Arcadis Project No.:
MI001322.0001

Subject:
DEQ Information Request Regarding Ford LTP
On site VI Investigation Plan

Response to MDEQ Request for Information

Ford Livonia Transmission Plant

VOC SSD System

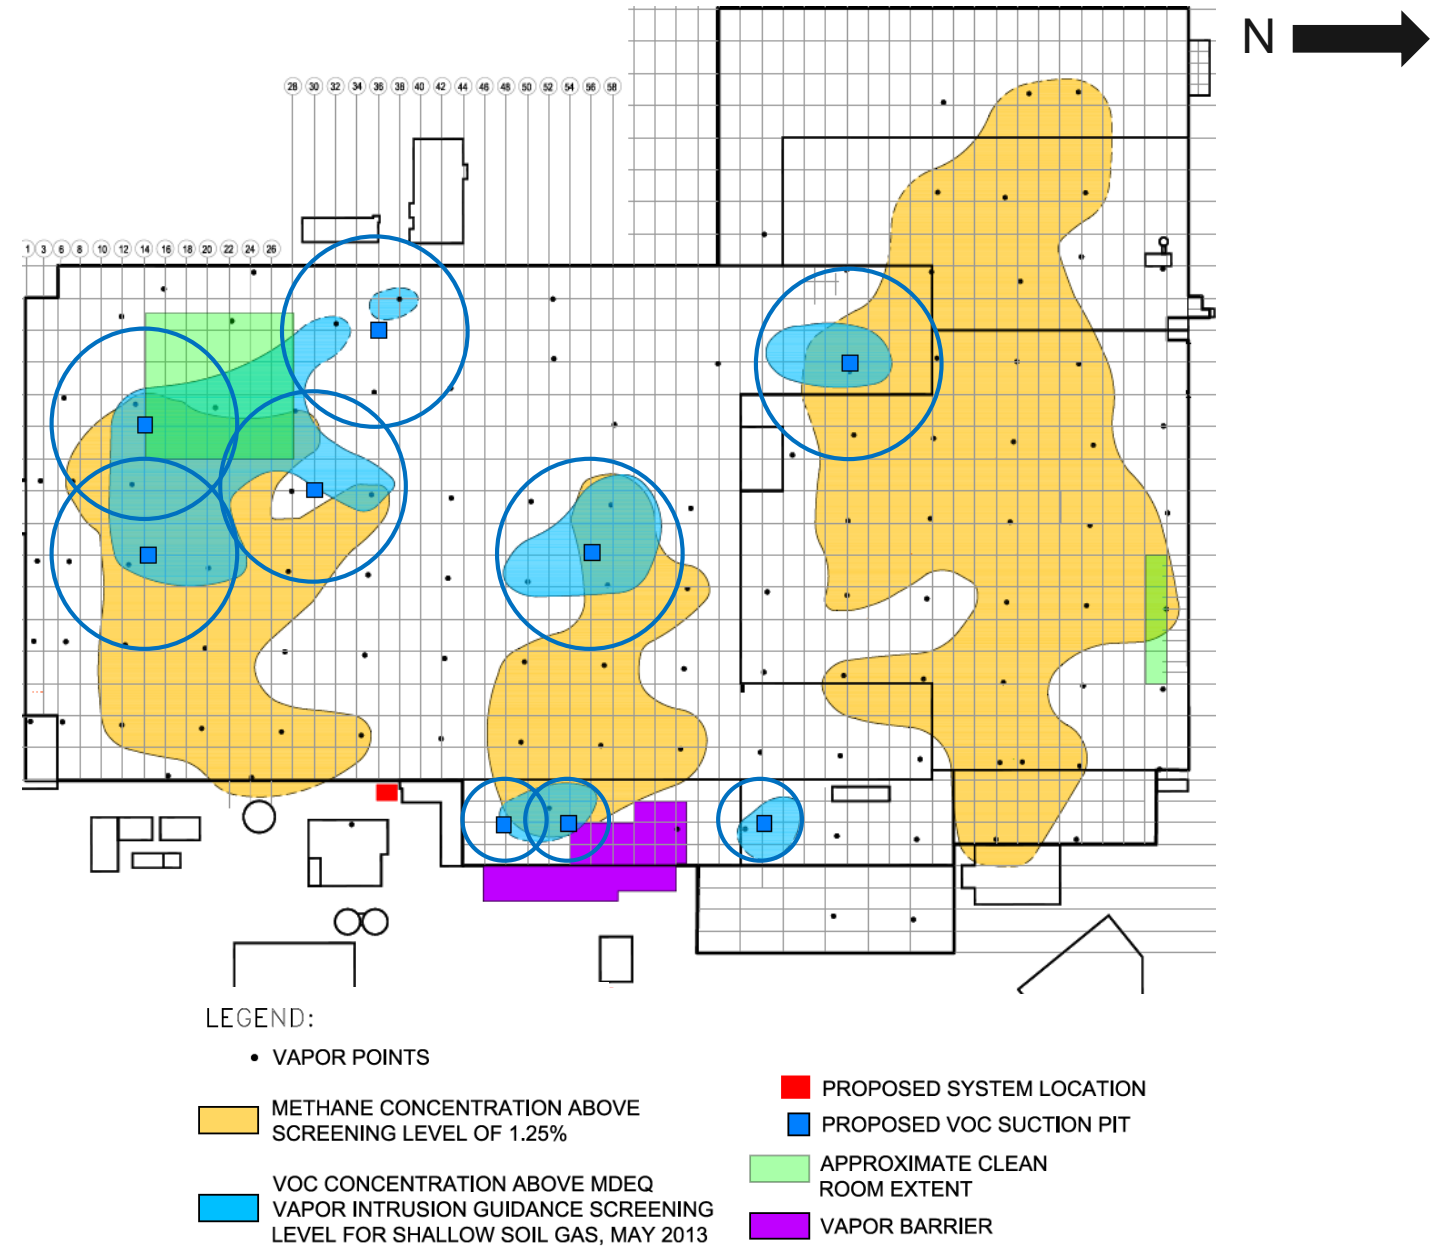
In response to the presence of VOCs and methane beneath the building, Ford has started to design a pre-emptive sub-slab depressurization system to ensure that vapor intrusion cannot occur in the future. Initial steps towards building mitigation included a review of building construction (Slide 36) and completion of sub-slab depressurization pilot testing (Slide 37). Pilot testing was conducted December 28 through 30, 2016 at five areas of the plant where VOC and methane concentrations were present in the sub-slab and within areas constructed at different times to determine the parameters necessary for sub-slab depressurization (SSD) system design in each of these areas. Results of the pilot testing indicated vacuum propagation results across most of the plant (Slides 38 through 43).

Slide 44 presents a conceptual design of the SSD system. The performance of this system will be evaluated and used to further the design of any additional SSD coverage to be incorporated as applicable.

Potential Historical Sources

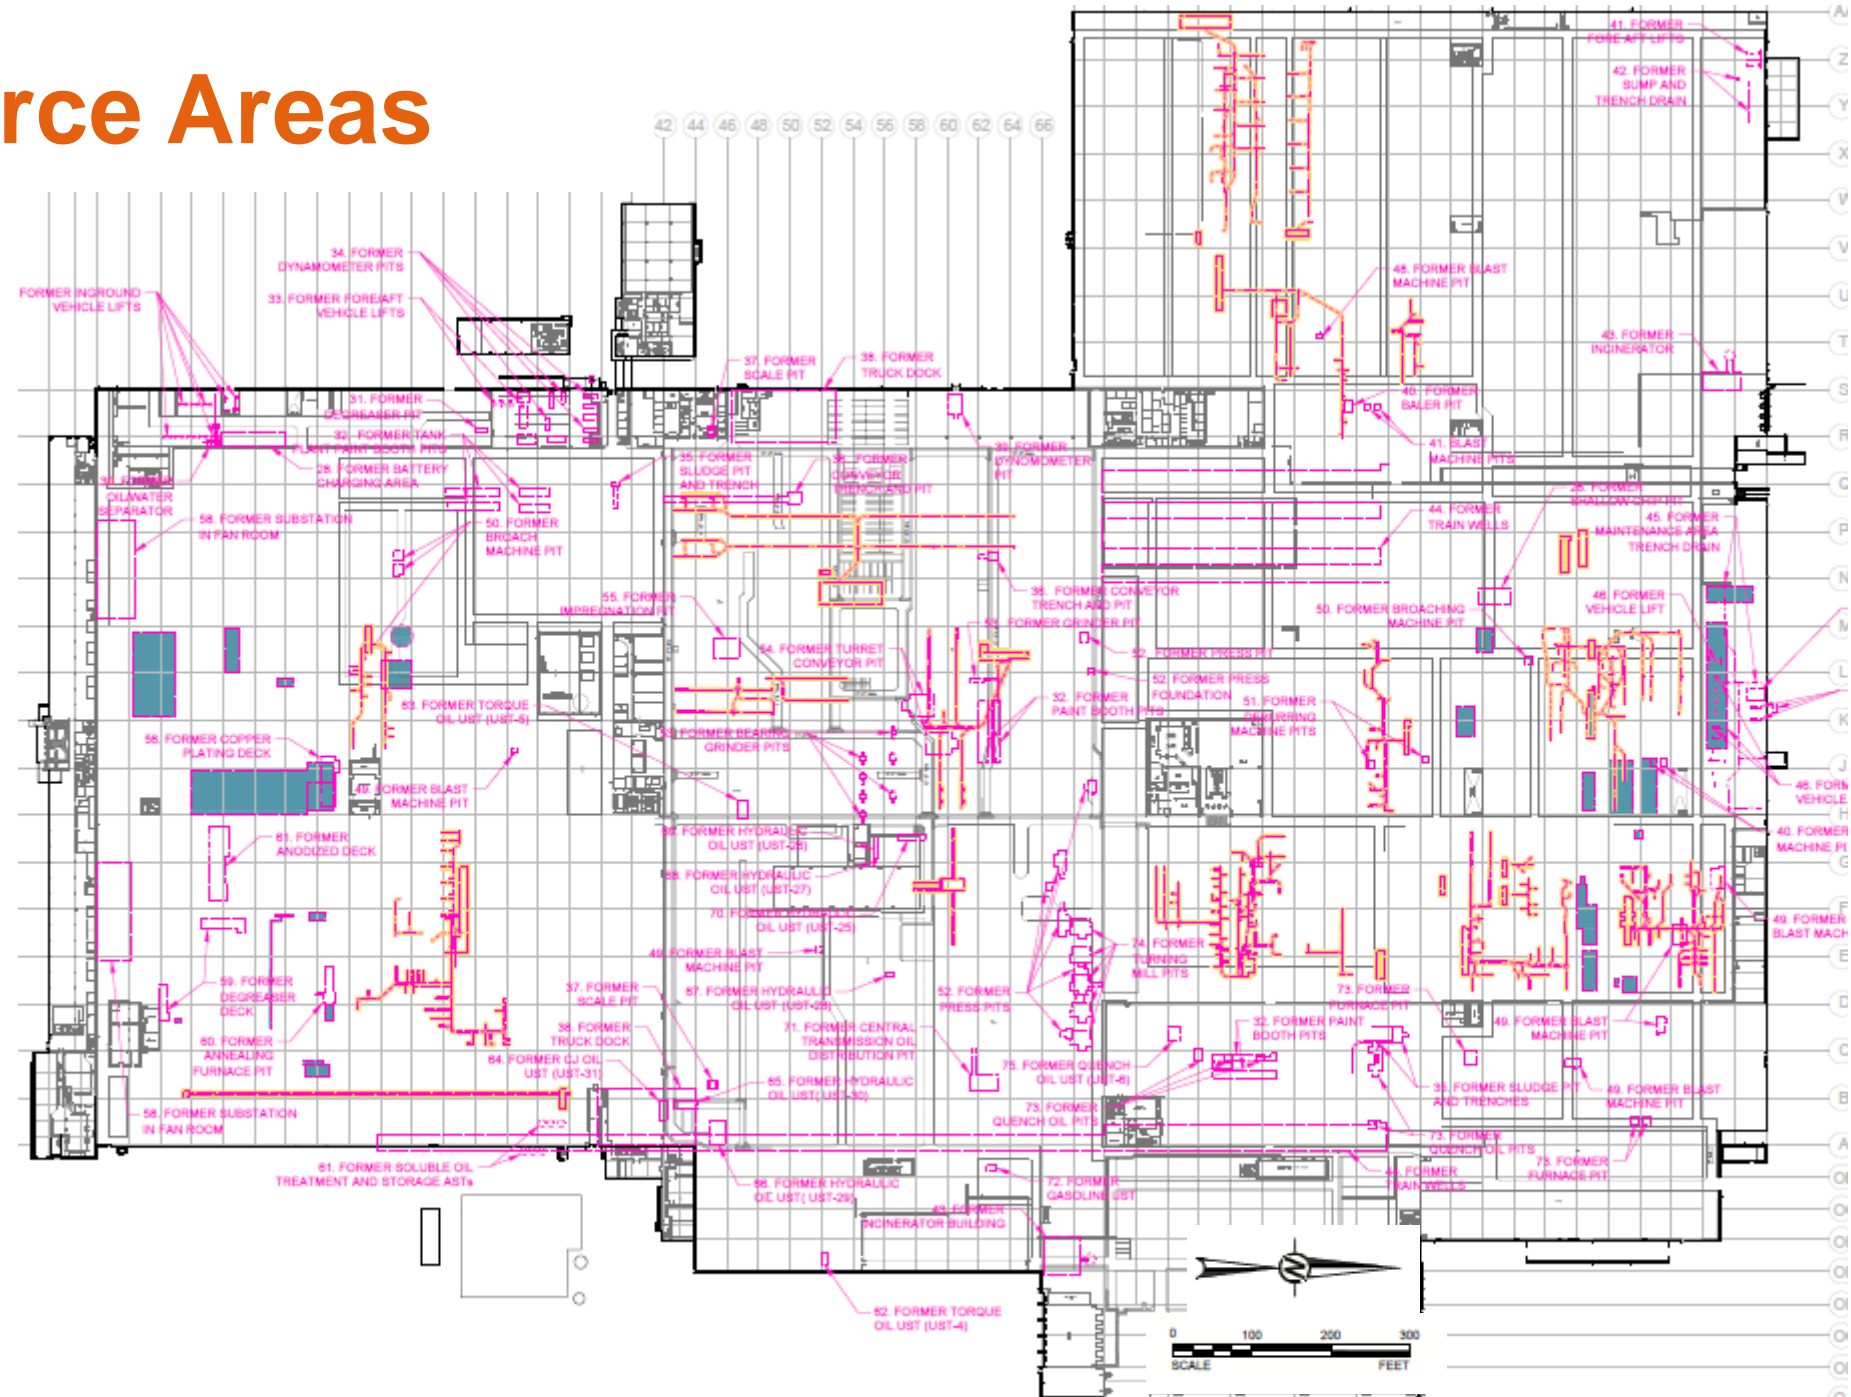
Comment #3: *In 2016, the specific source of the contamination had not yet been determined. Has this since been determined? Is the source estimated to be from a single point/catastrophic release, or is there more likely a history of substance mismanagement which lead to multiple nearby sources which have over time formed to create the greater issue which created the effects now being observed offsite? Does any information exist indicating whether this was one substance or multiple? We understand this may be difficult to nail down, but if any determinations have been made beyond the hypotheses outlined in the April 2016 memo, please let us know.*

Based on historical operations, there are multiple potential historical sources beneath the LTP building (Slide 46). As shown on Slide 46, numerous pits, tanks, and pipe runs were historically present beneath the building that may have contributed to the release of LNAPL and solvent compounds. In particular, the waste conveyance lines may have contributed to impacts at the Site from potential leaks. However, the results of the sampling data have suggested several areas that may be contributing to soil, groundwater, and vapor impacts at the Site. Based on the occurrence of VOCs in sub-slab soil gas samples, as well as the distribution of VOC impacts observed in soil, groundwater, and LNAPL samples, six areas have been

48-Inch Line before Rehabilitation

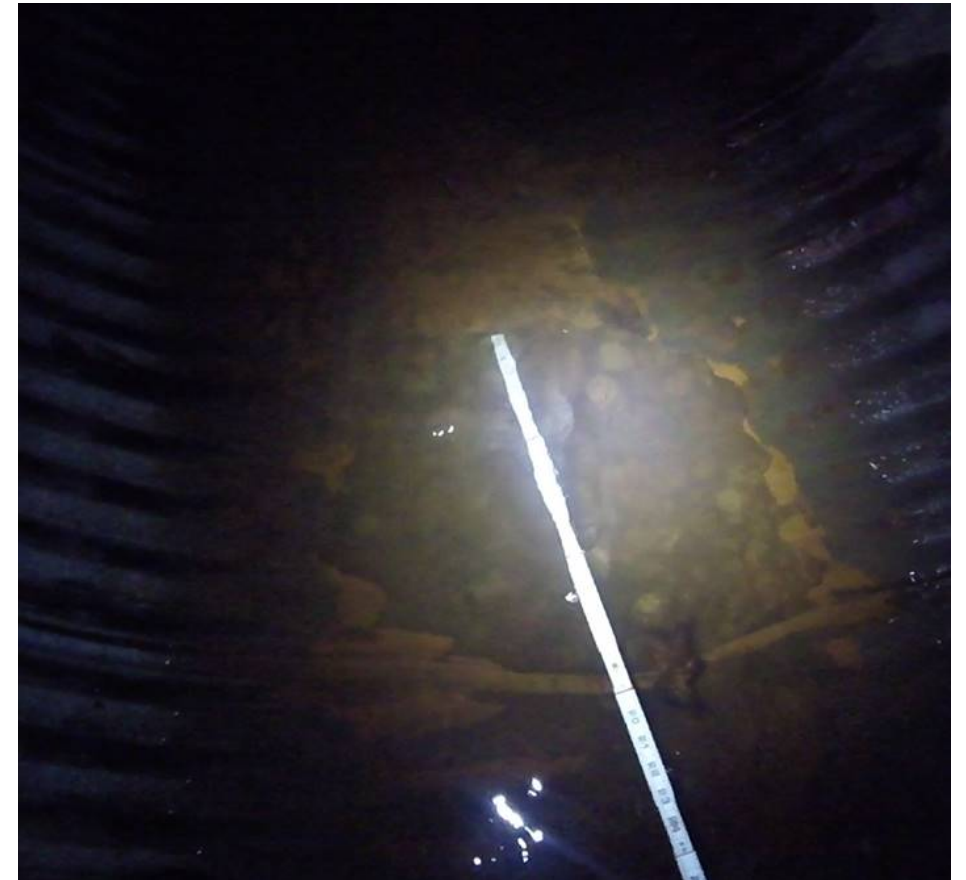
Comment #5: *Is the storm drainage condition which is believed to have helped slow down the migration of this contamination to the south still present? Is this still being addressed for a more appropriate long-term solution in which the contaminated groundwater is not being intercepted by the storm sewer, or is a long-term solution now in place?*

Post-construction CCTV indicated that the 48-inch CMP was successfully rehabilitated (Slide 71)
